# Technical Memorandum

<b>To</b>	TRK Property Group Pty Ltd	<b>Date</b>	13 May 2026
<b>Prepared by</b>	Arthur Stamatiou, Modus Senior Traffic and Waste Engineer	<b>Approved by</b>	Tetteh Anang, Modus Transport Advisor (RPEQ 28656)
<b>Location</b>	193 & 203 Beams Road, Taigum		
<b>Subject</b>	Proposed Townhouse Development – Traffic Engineering Letter in response to the Council Further Advice Notice for a Minor Change Application		
<b>Status</b>	Final	<b>Attachments</b>	<b>Appendix A:</b> Council Further Advice Notice <b>Appendix B:</b> Development Plans

Figure 6-1 Intercom Location

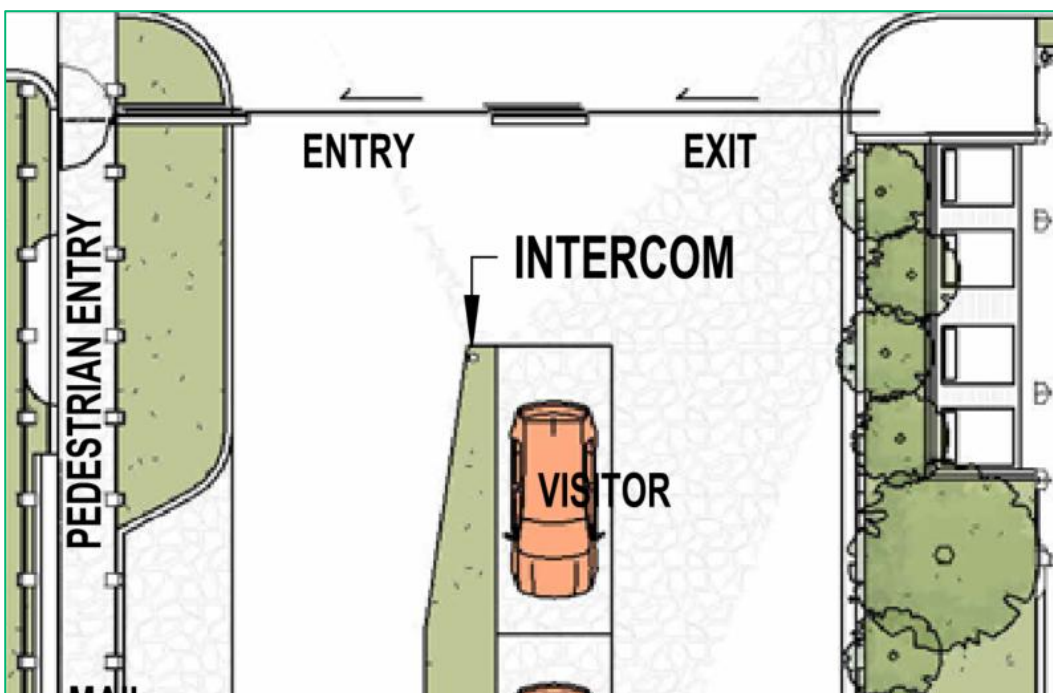
*Submit amended plans which indicate that an intercom system or similar will be provided to permit 24-hour visitor access.*

The proposed development has been provided with an intercom system to permit 24-hour visitor access as illustrated in Figure 6-1.
